MAHONING ROAD NE
 STA-0153-01.70

REVISIONS:
 CONSTRUCTION BIDDING SET
 APPENDIX NO. 1

REVISIONS	DATE	BY
CONSTRUCTION BIDDING SET	4/21/14	GEA
ADDENDUM NO. 1	5/7/14	GEA

STREETSCAPE PLAN
 STA. 54+75 TO STA. 66+50

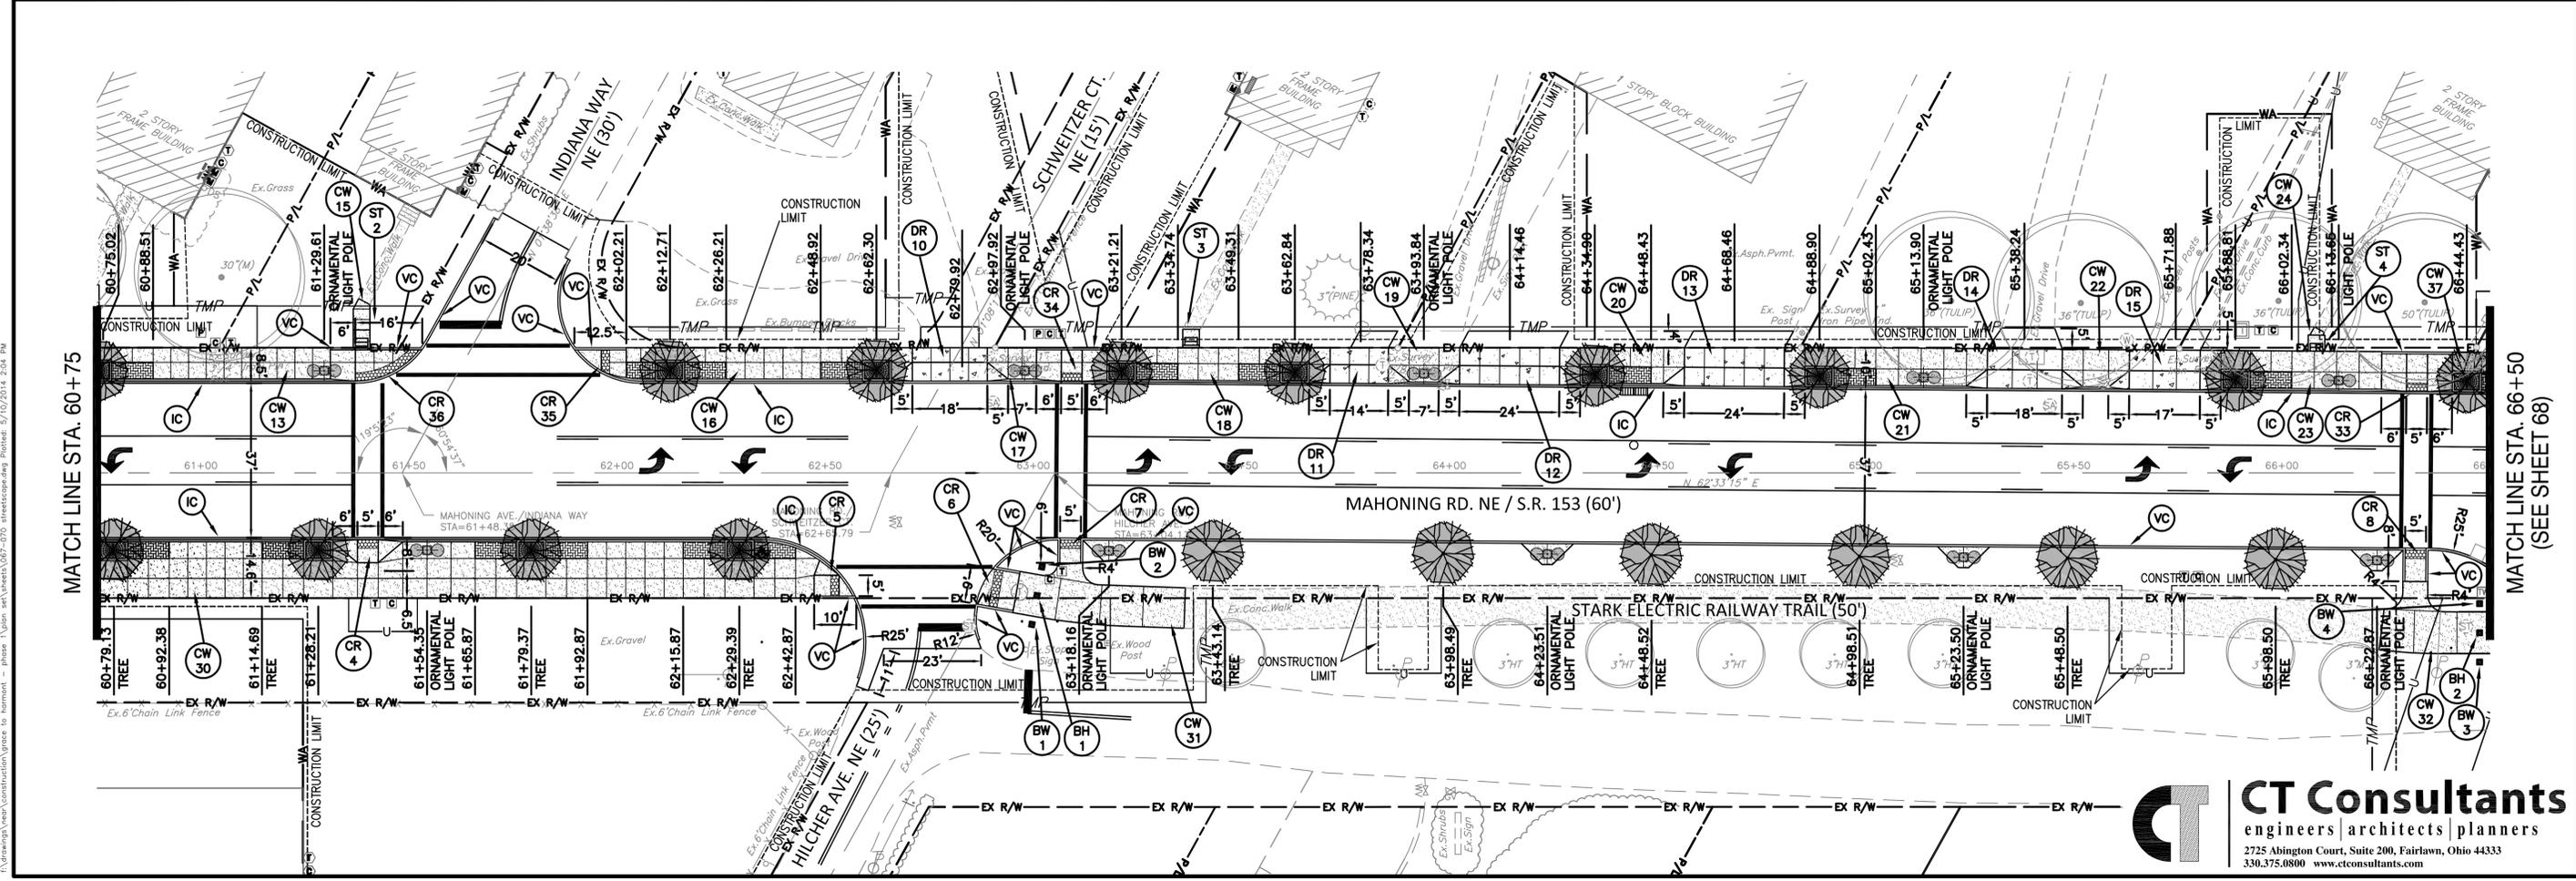
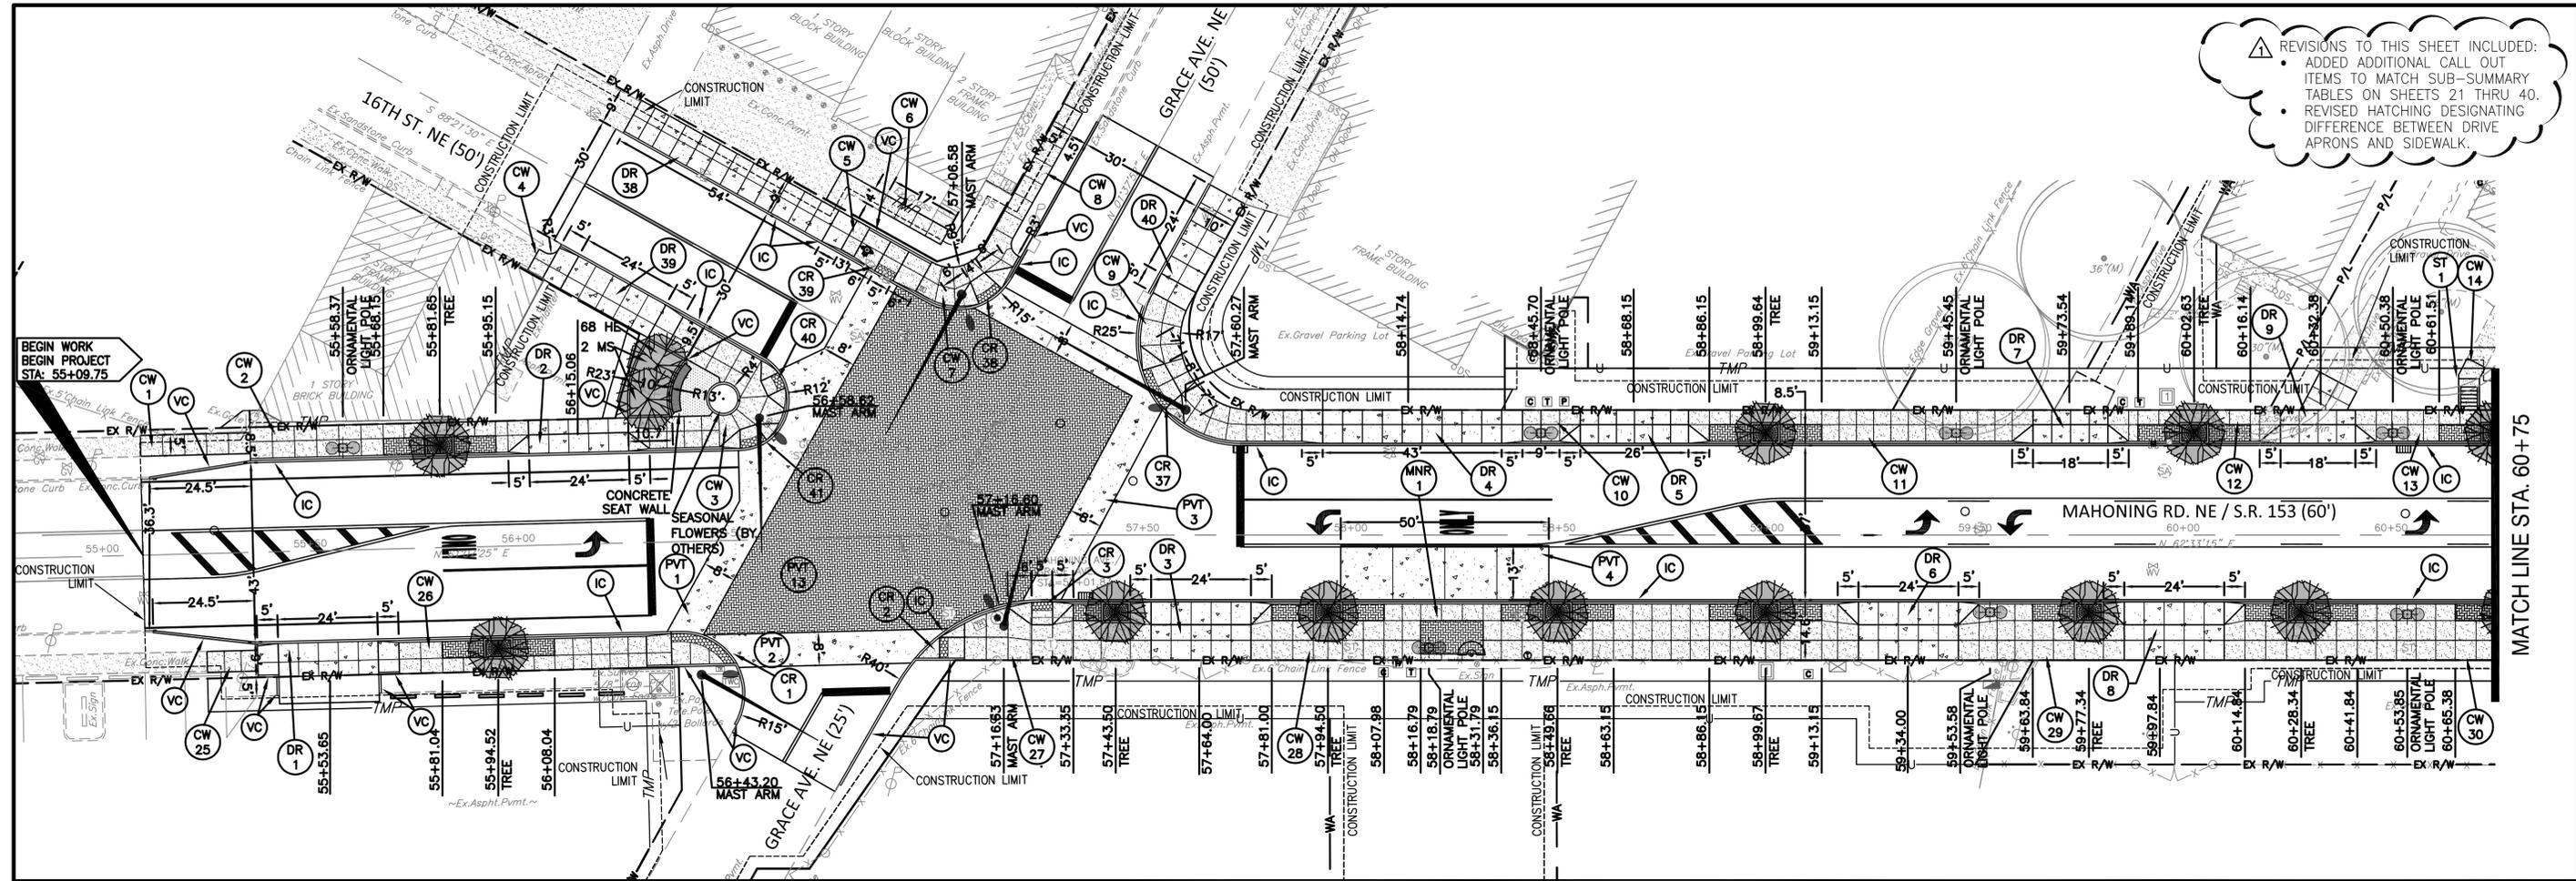
REVISIONS TO THIS SHEET INCLUDED:
 • ADDED ADDITIONAL CALL OUT ITEMS TO MATCH SUB-SUMMARY TABLES ON SHEETS 21 THRU 40.
 • REVISED HATCHING DESIGNATING DIFFERENCE BETWEEN DRIVE APRONS AND SIDEWALK.

STREETSCAPE PLAN
 STA. 66+50 TO STA. 78+00

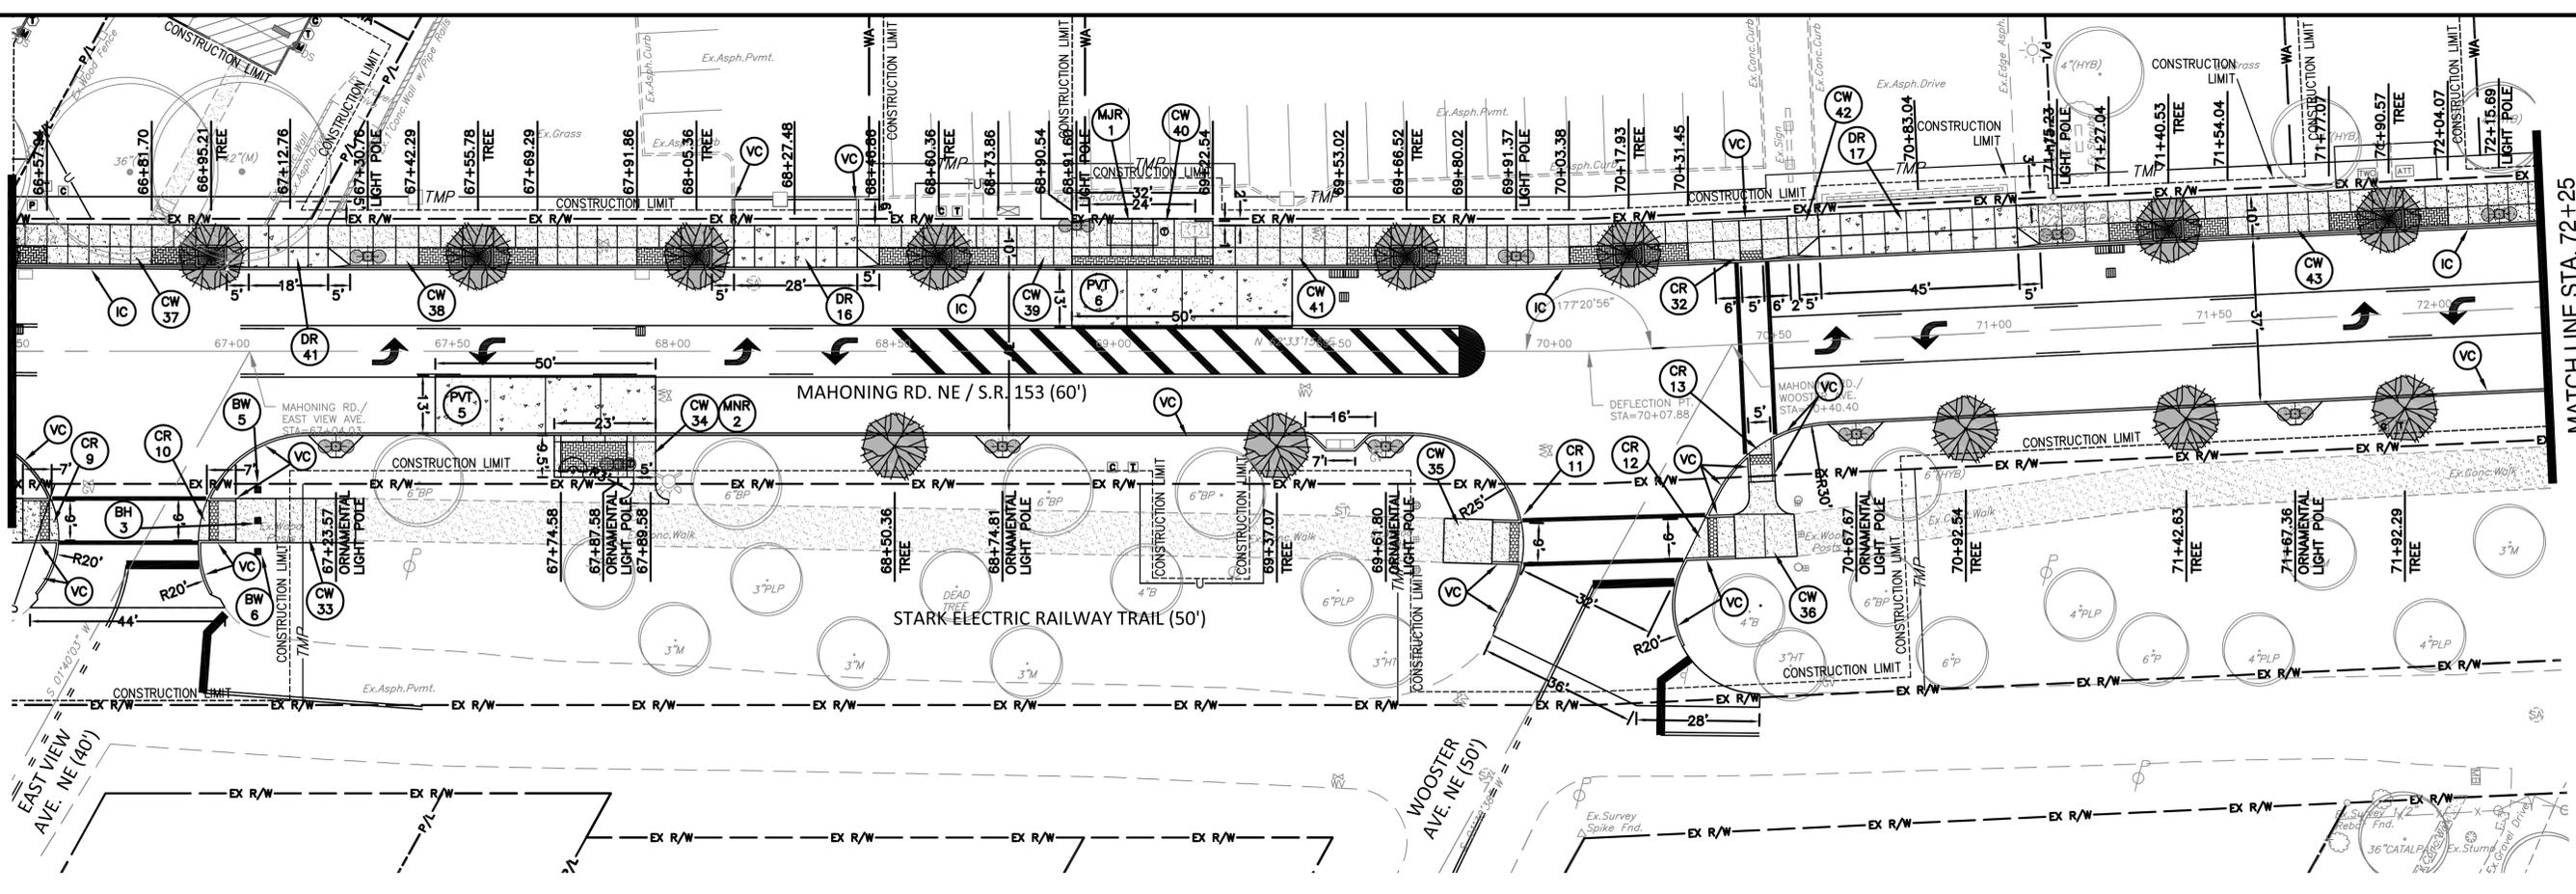
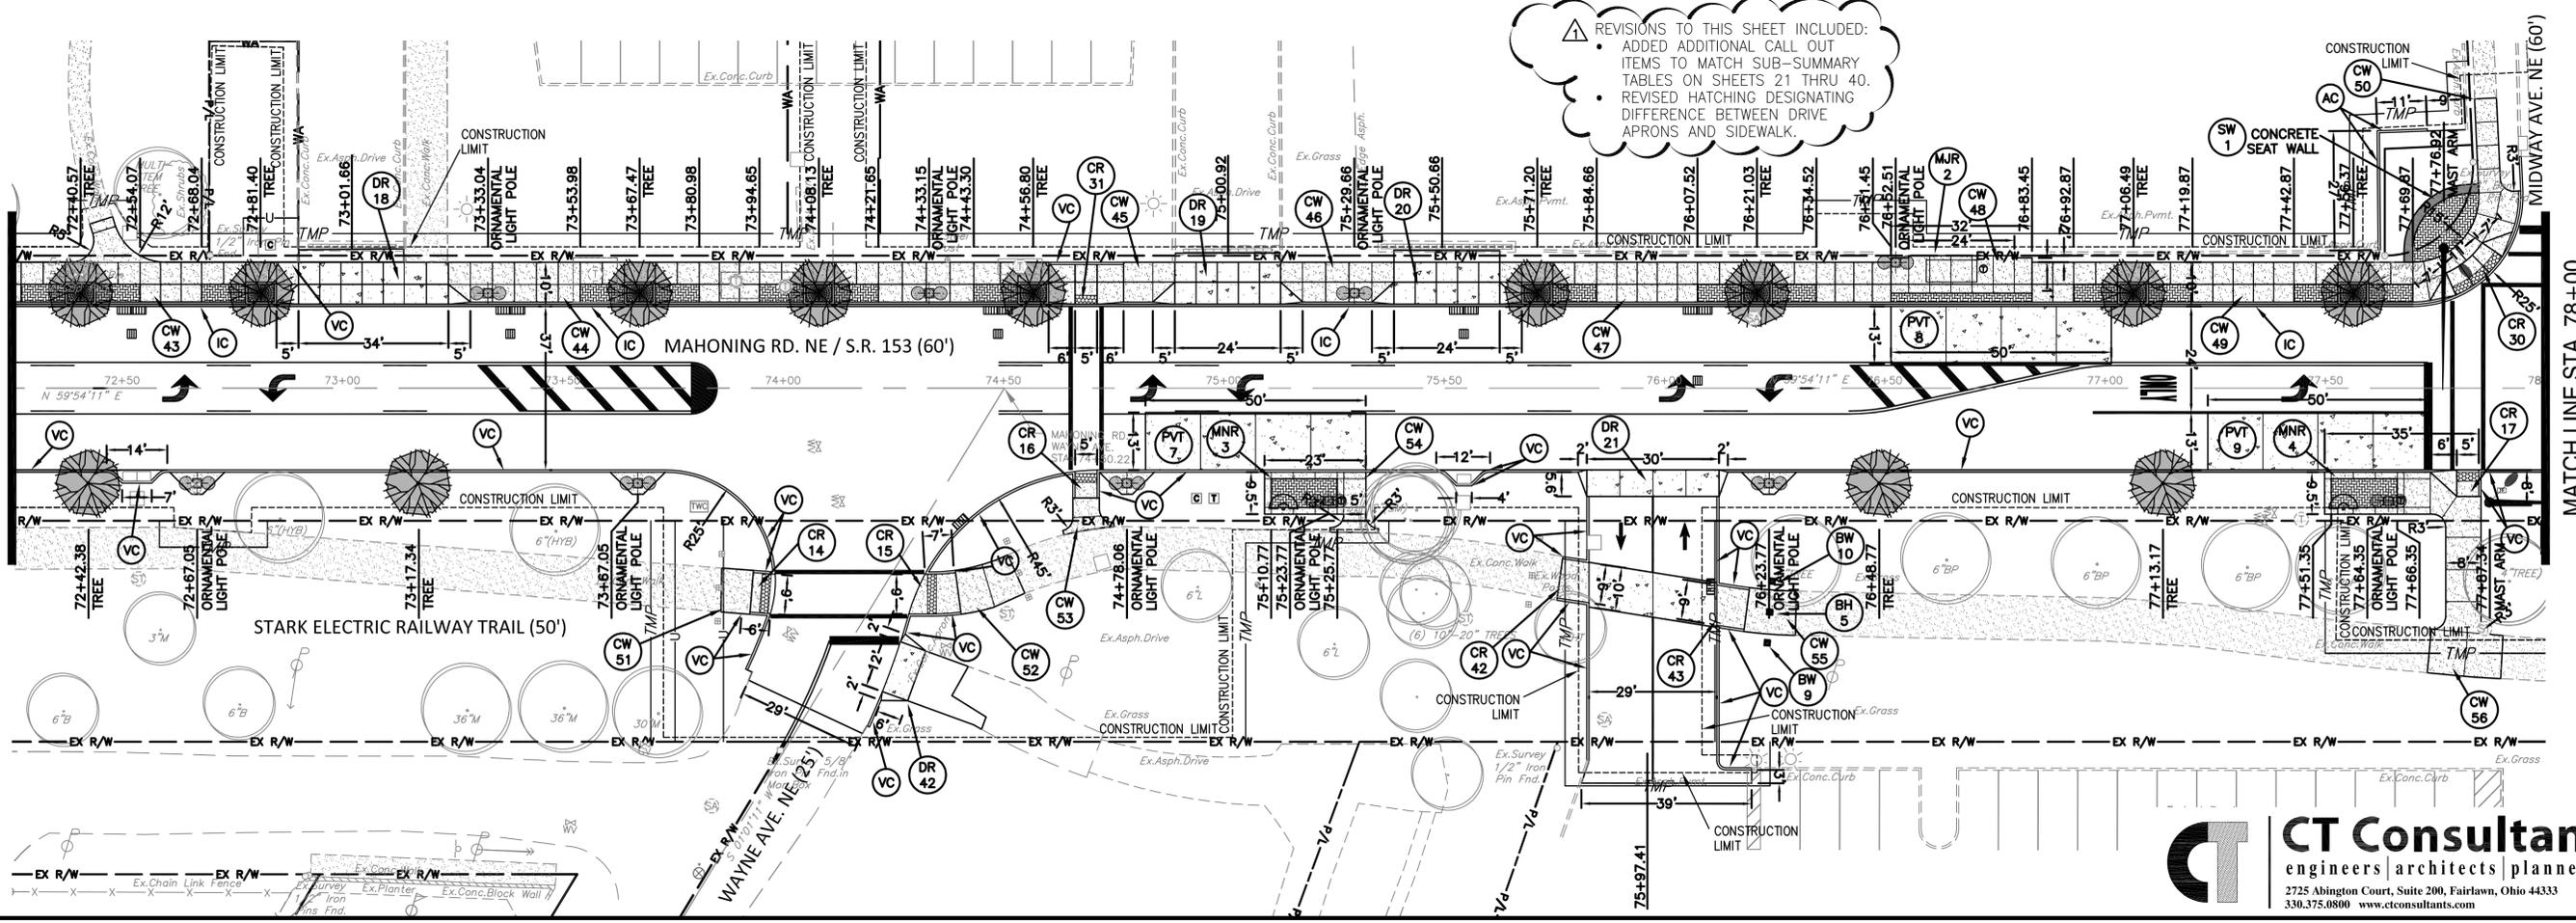
REVISIONS TO THIS SHEET INCLUDED:

- ADDED ADDITIONAL CALL OUT ITEMS TO MATCH SUB-SUMMARY TABLES ON SHEETS 21 THRU 40.
- REVISED HATCHING DESIGNATING DIFFERENCE BETWEEN DRIVE APRONS AND SIDEWALK.
